RFI No. 001: SOLICITATION REQUEST FOR INFORMATION

Project: Port Townsend, WA Main Office Exterior Restorations

Project Number: B14633

Boiler Room Windows

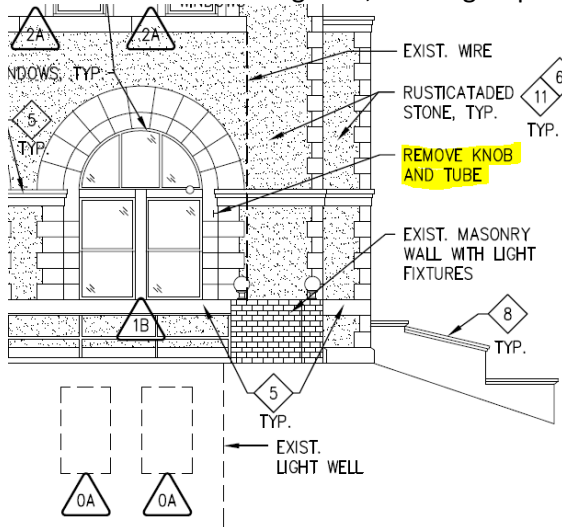
Q8: In the basement, there exists windows through which ducting passes. This condition exists in the boiler room on (3) windows. We are proposing to finish these windows in place. Please confirm or provide direction.

A8: Yes. Repair of windows and sashes can be performed in place.

Exterior Lighting

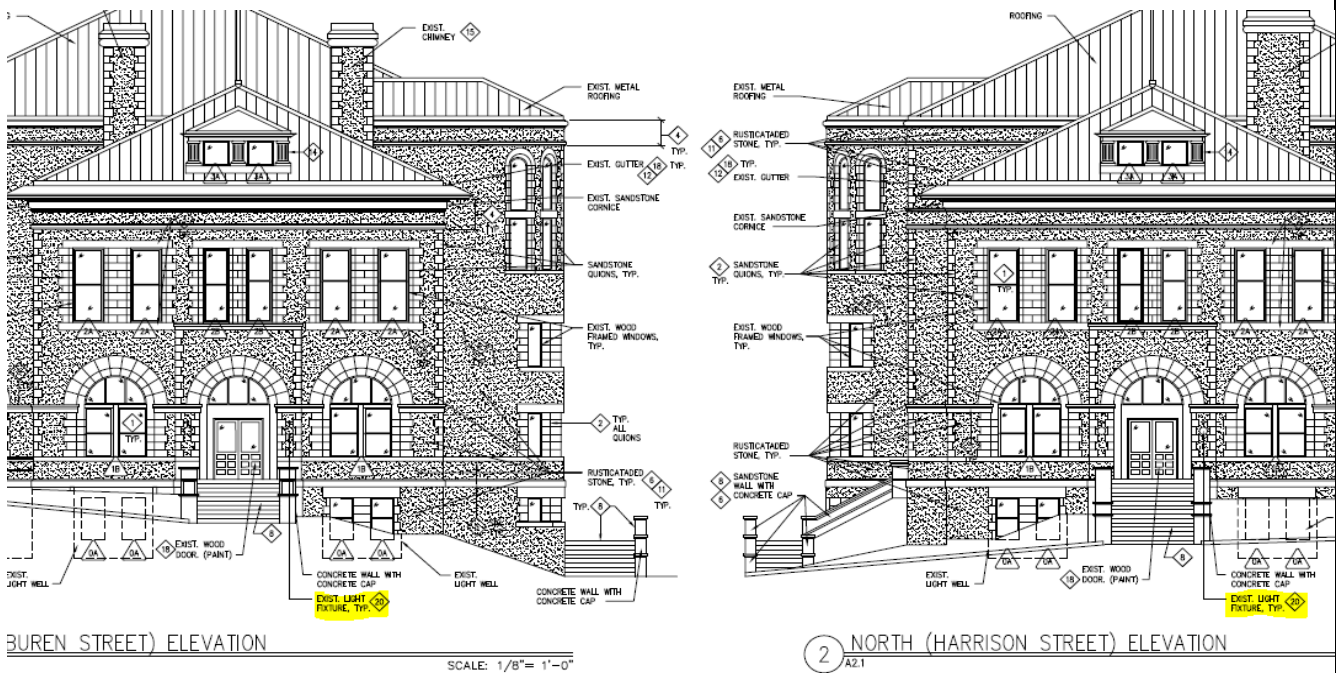
- 19 ABATE EXISTING PAINT FROM DOORS. PREPARE, PRIME AND PAINT DOOR TO MATCH THE EXISTING COLOR.
- 20 REMOVE EXISTING LIGHT FIXTURE AND REPLACE WITH NEW. REUSE EXISTING CIRCUITING AND WIRING.

Q10: Are we to remove the fixture and replace it with a modern fixture to match as close as possible, or reuse the existing if possible, to preserve historical?

A10: Yes.
